Access Compliance Report

Public Rights-of-Way

Intersection ID: 45891	Main Street: PROSPERITY_CHURCH_RD	Cross Street: STONE_PARK_DR	Location: NW
ADA ID: C28EF8F9A69A	Ramp Type: PerpDiag	Initial Pass/Fail: Fail	Overall Compliance: No
		Severity Score: 10

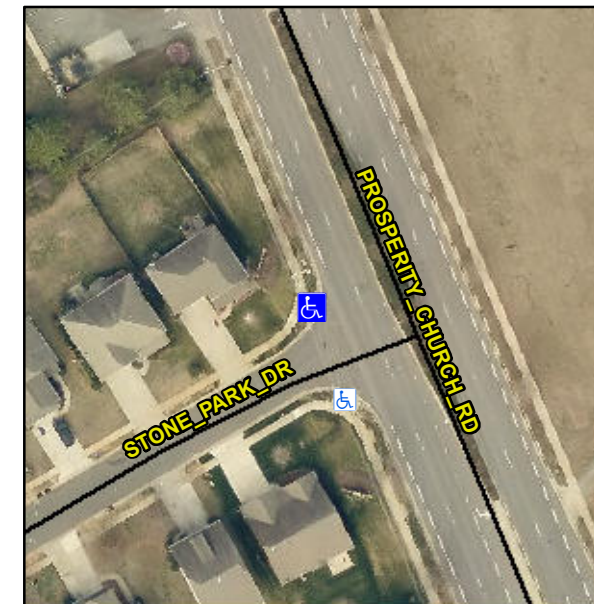
Not Found, R304.5.1, R304.5.3

Compliance	Description	Data	Compliance	Description	Data
N/A	Ramp Length (in)	73.0	Yes	Ramp Slope (%)	7.0
No	Ramp Width (in)	36.0	No	Ramp XSlope (%)	3.0
N/A	Flare Type LT	N/A	N/A	Flare Type RT	N/A
N/A	Flare Slope LT (%)	N/A	N/A	Flare Slope RT (%)	N/A
N/A	Flare Traversable LT?	N/A	N/A	Flare Traversable RT?	N/A
N/A	Landing Length (in)	N/A	N/A	DWS Provided?	N/A
N/A	Landing Width (in)	N/A	N/A	DWS Contrast?	N/A
N/A	Landing Slope (%)	N/A	N/A	DWS Length (in)	N/A
N/A	Landing X Slope (%)	N/A	N/A	DWS Full Width?	N/A
N/A	Landing Curb? (Y/N)	N/A	N/A	DWS Offset (in)	N/A
N/A	Shared Landing?	N/A			
N/A	Gutter Ponding?	N/A	N/A	Gutter Slope (%)	N/A
N/A	Gutter Lip Ht (in)	N/A	N/A	Gutter X Slope (%)	N/A
N/A	Painted X Walk1?	No	N/A	Painted X Walk2?	No
	X Walk 1 Direction	To E		X Walk 2 Direction	To S
N/A	X Walk 1 Width (in)	N/A	N/A	X Walk 2 Width (in)	N/A
	X Walk 1 Slope (%)	2.2		X Walk 2 Slope (%)	3.4
	X Walk 1 X Slope (%)	2.5		X Walk 2 X Slope (%)	0.9

Remove & Replace Curb Ramp With Two New Directional Ramps or Equivalent.
